REV	DATE	DESCRIPTION
△	10/13/15	SHEET ADDITIONS
△	02/03/16	MODIFICATIONS FOR CHANGED DECK TYPE

PROJECT NAME: WAITSFIELD

PROJECT NUMBER: BF 013-4(39)

TYPICAL BRIDGE SECTION
SCALE 3/8" = 1'-0"

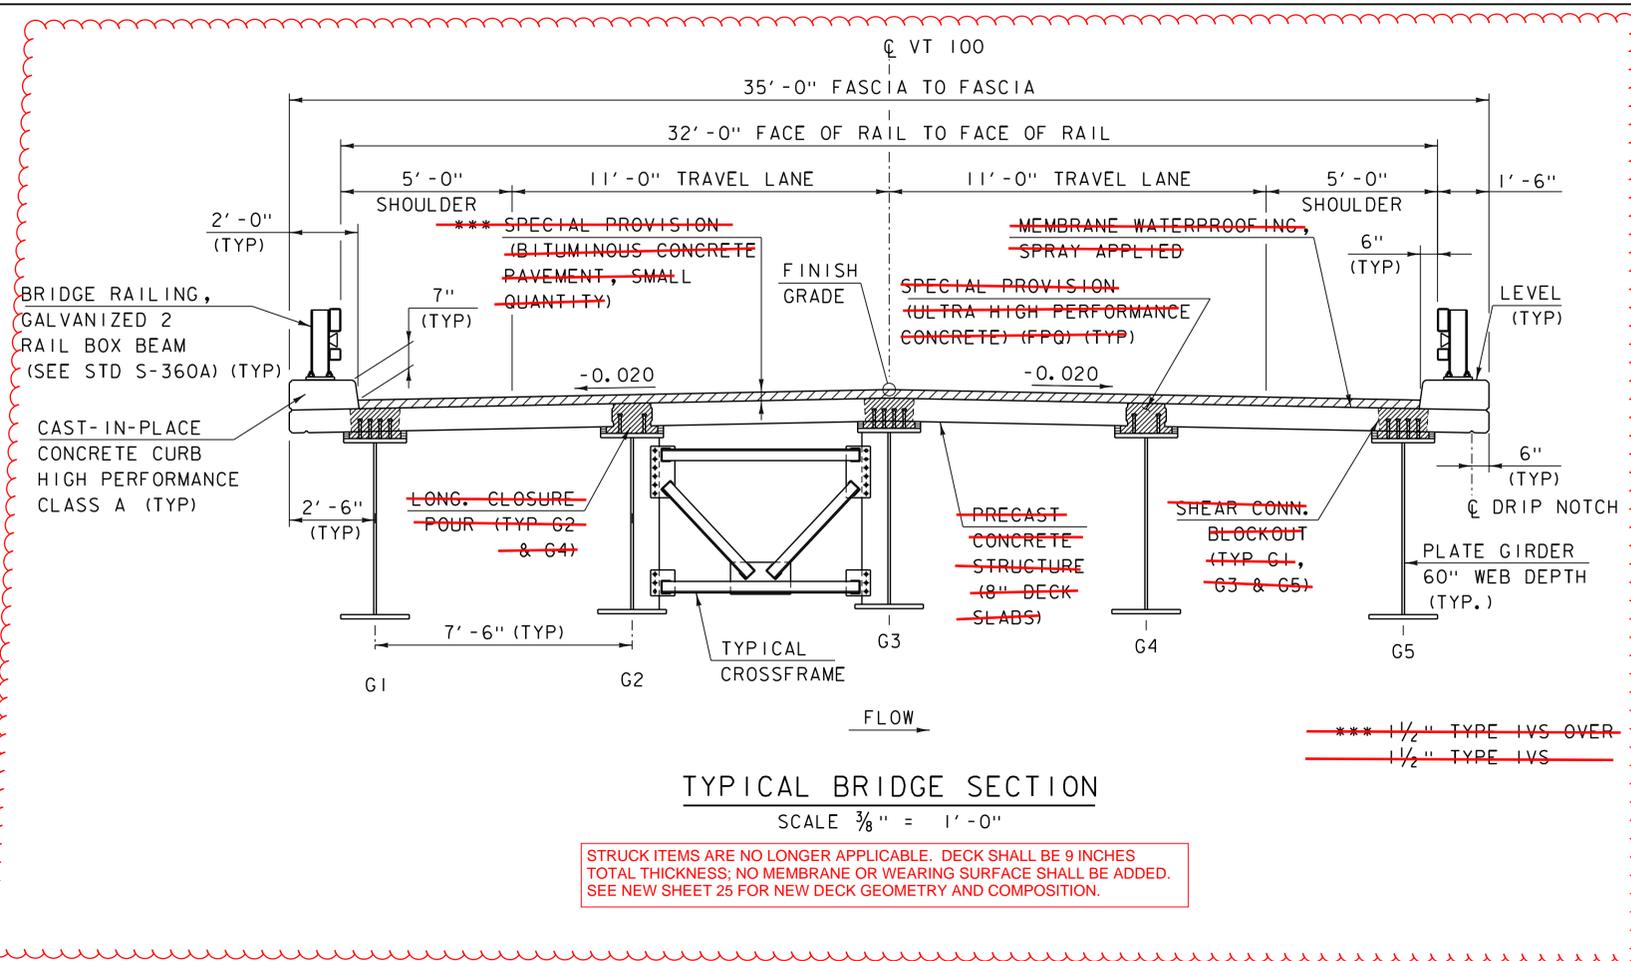
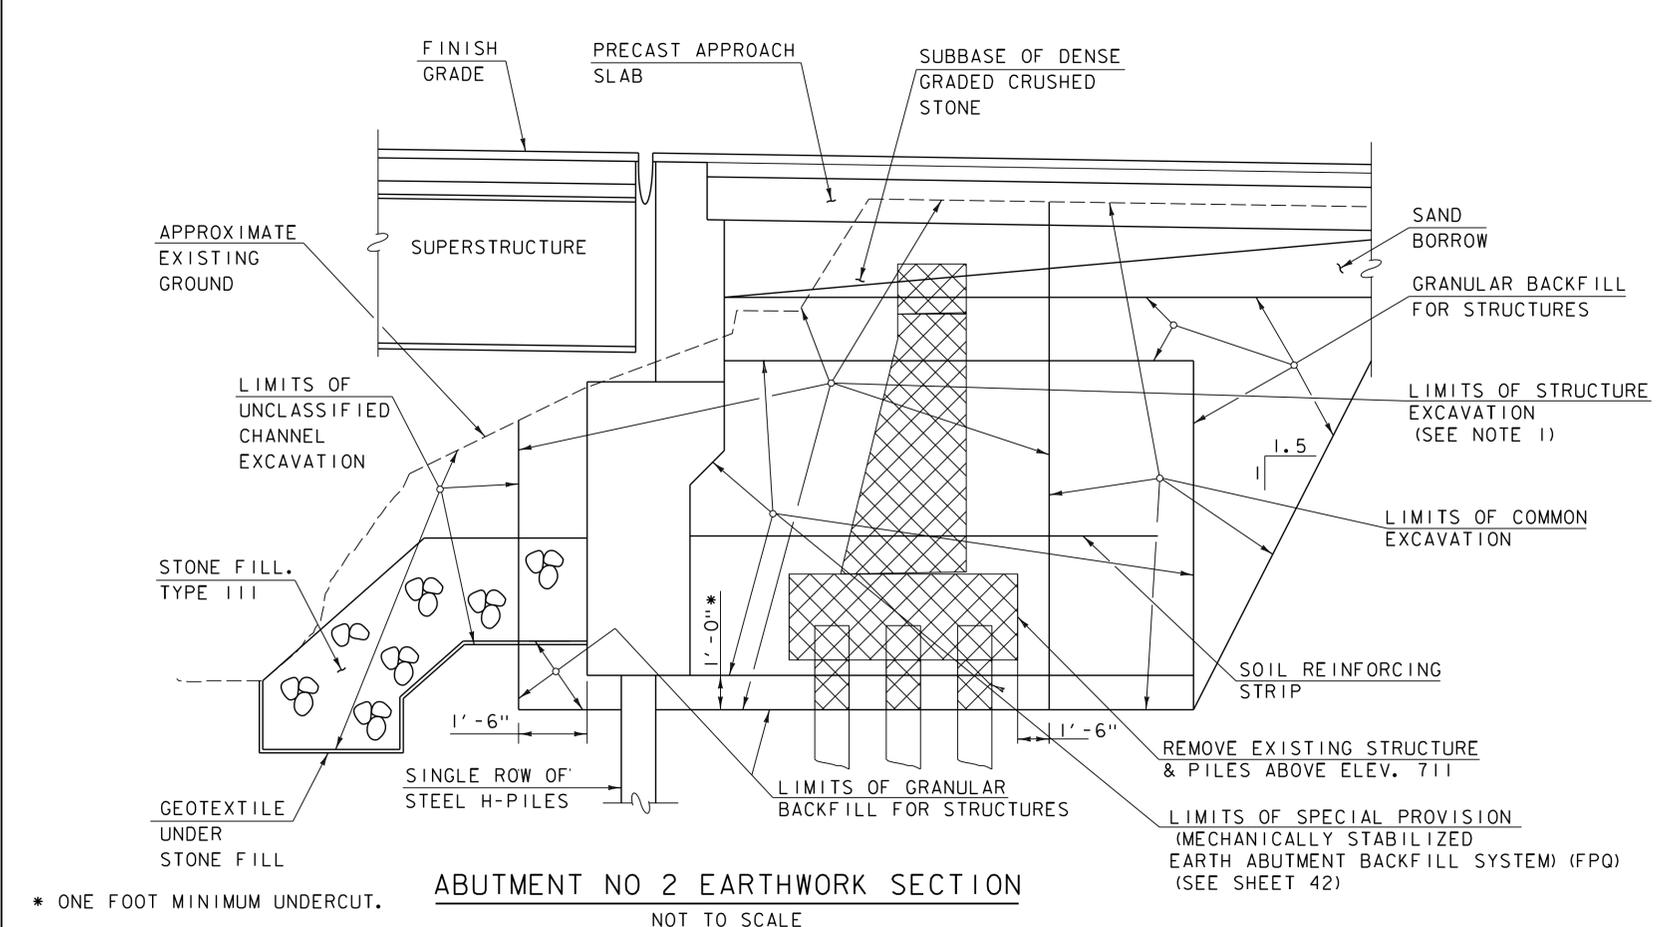
STRUCK ITEMS ARE NO LONGER APPLICABLE. DECK SHALL BE 9 INCHES TOTAL THICKNESS; NO MEMBRANE OR WEARING SURFACE SHALL BE ADDED. SEE NEW SHEET 25 FOR NEW DECK GEOMETRY AND COMPOSITION.

△ ALTERNATE LONGITUDINAL CLOSURE POUR SECTION

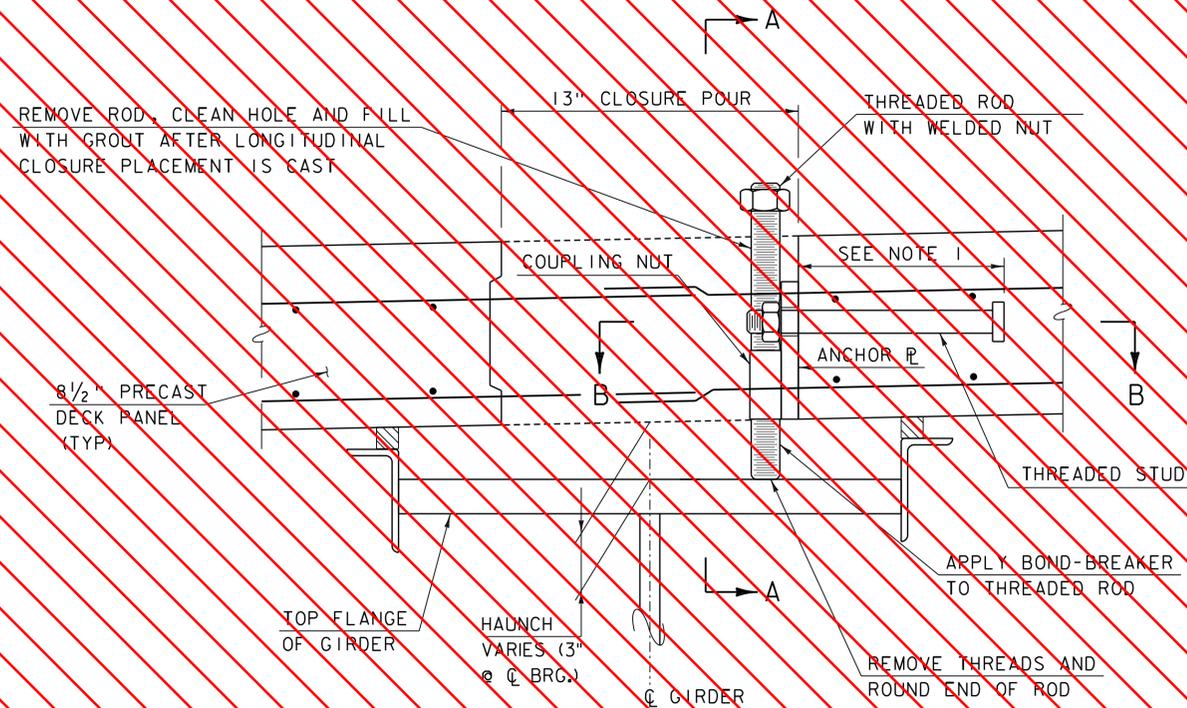
REV	DATE	DESCRIPTION
△	10/13/2015	ALTERNATE CLOSURE POUR ADDITION
△	10/13/2015	SHEET ADDITION

CROSSFRAME DETAIL
(INTERMEDIATE CROSSFRAME SHOWN)
SCALE: 1" = 1'-0"

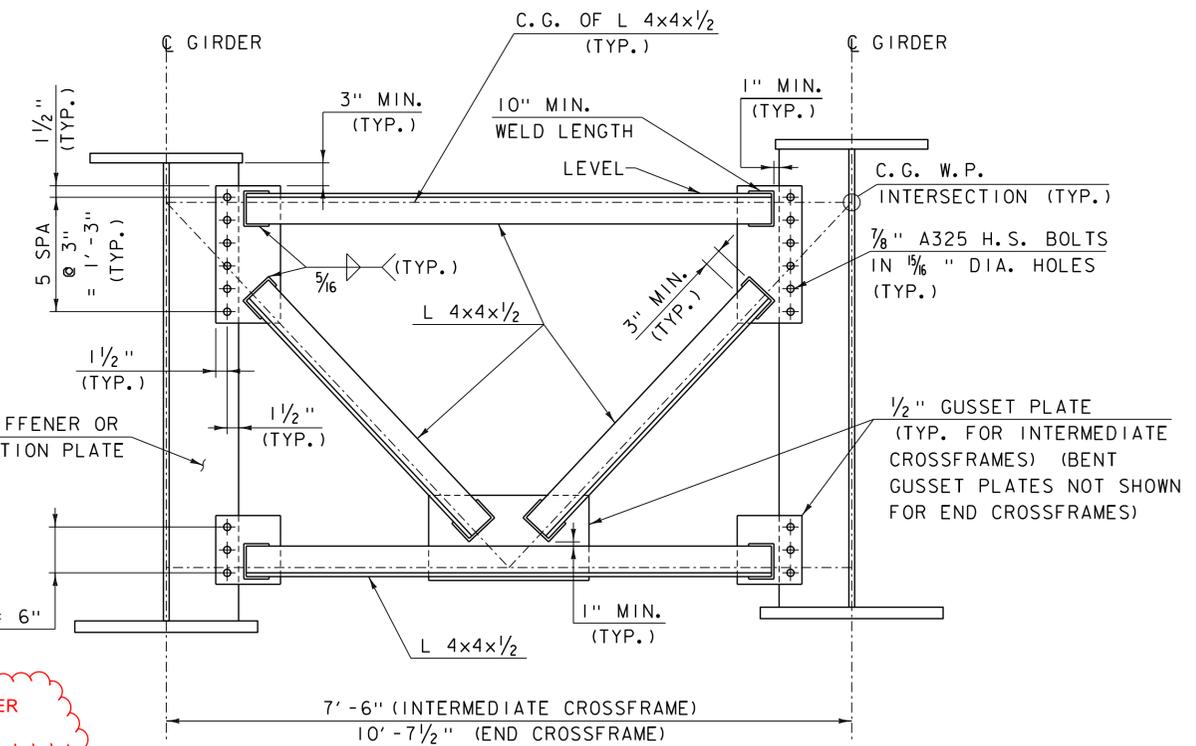
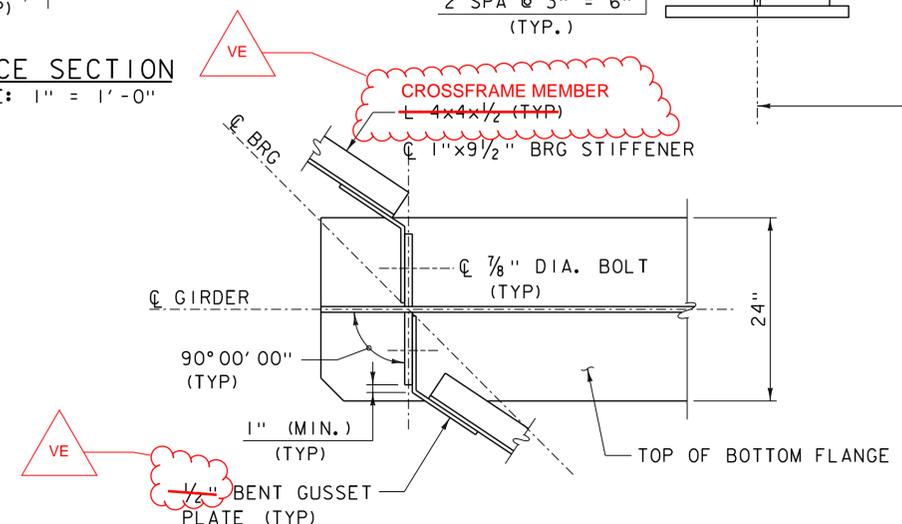
REV	DATE	DESCRIPTION
VE	02/03/16	MODIFICATIONS FOR CHANGED CROSSFRAME AT ABUT 2

APPROACH SLAB NO. 1 PLAN
 (APPROACH SLAB NO 1 SHOWN, APPROACH SLAB NO 2 SIMILAR)
 SCALE: 1/4" = 1'-0"

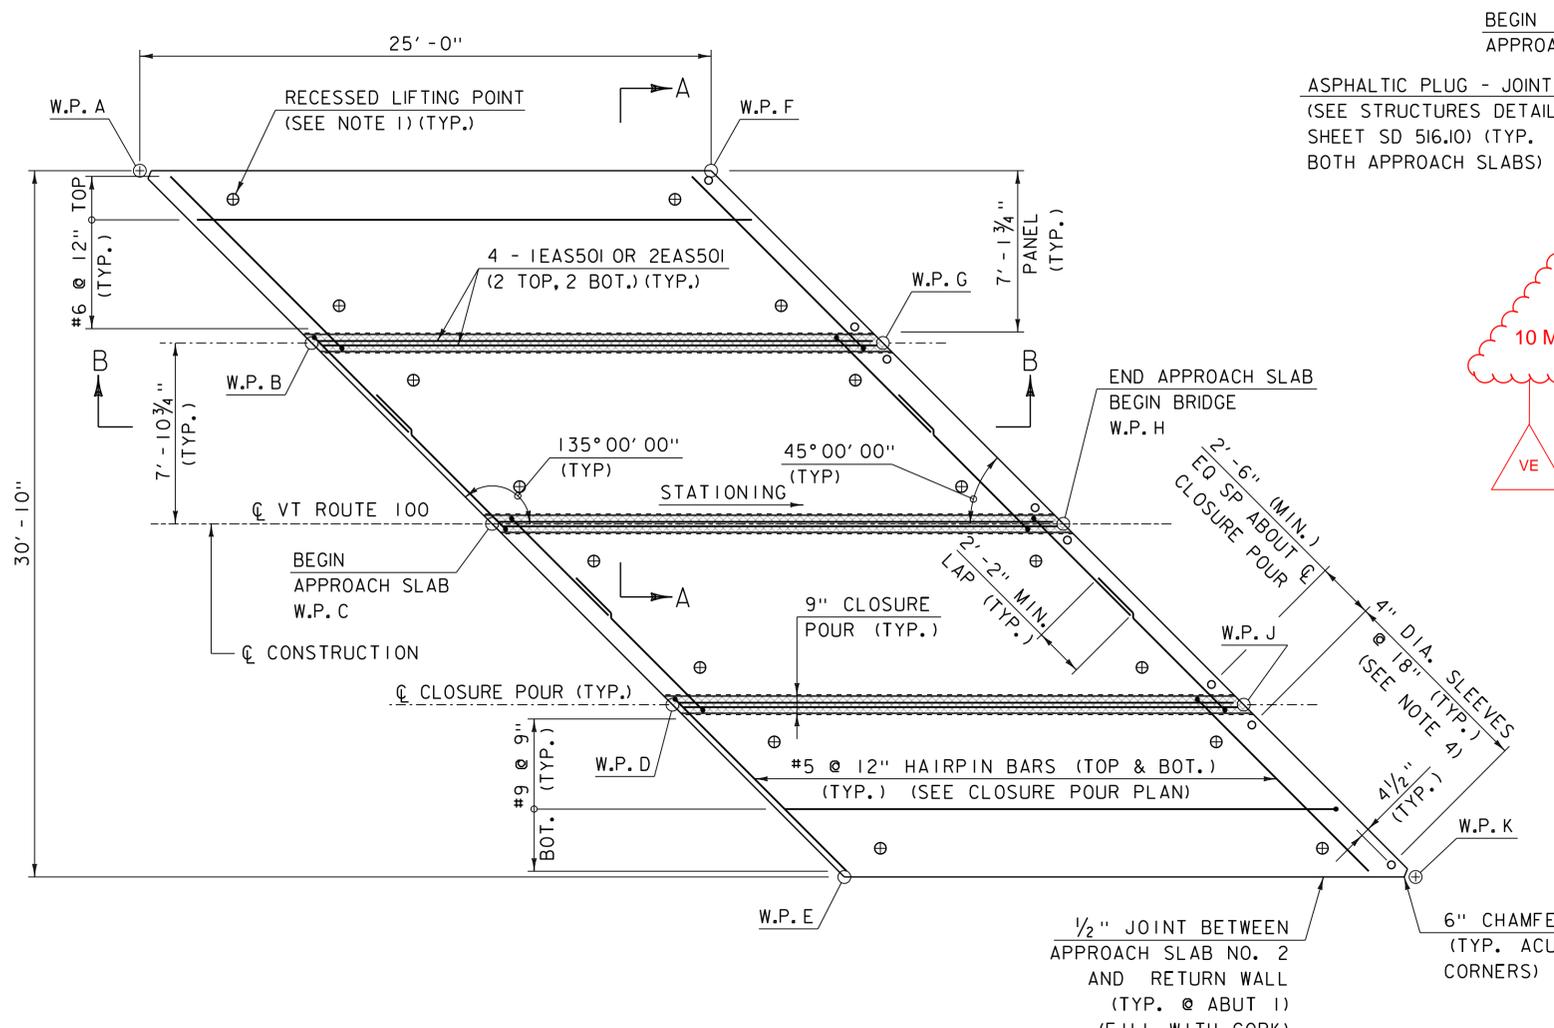
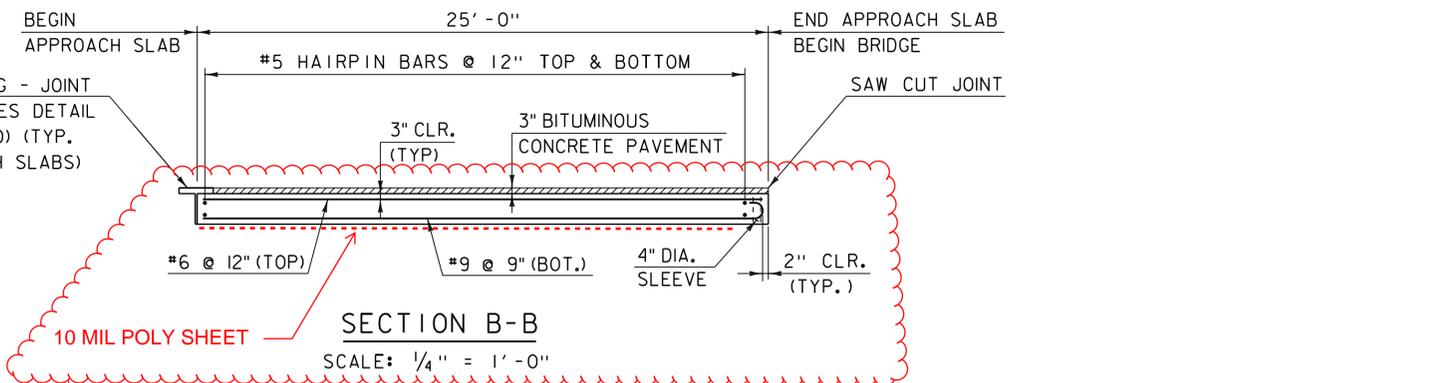
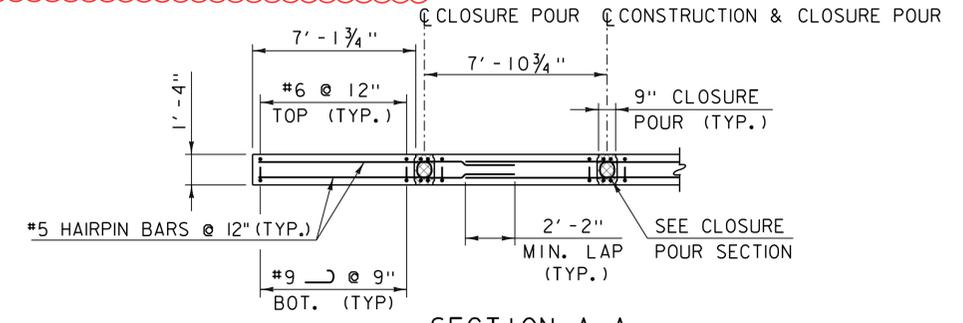
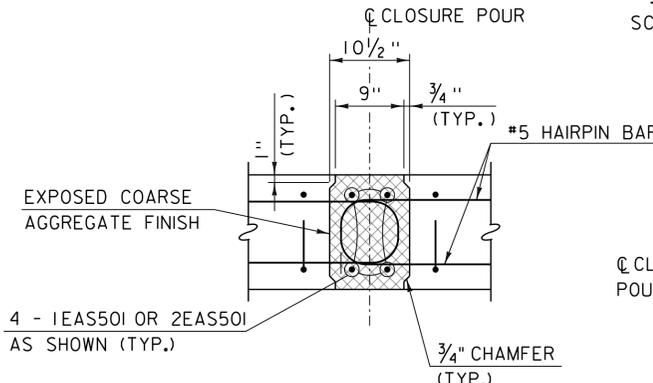
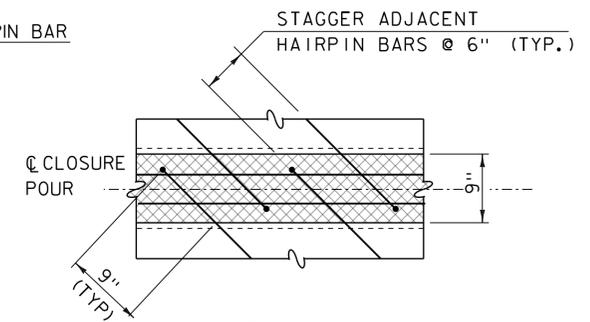
REV	DATE	DESCRIPTION
VE	02/03/16	MODIFIED CLOSURE POUR CONCRETE TYPE
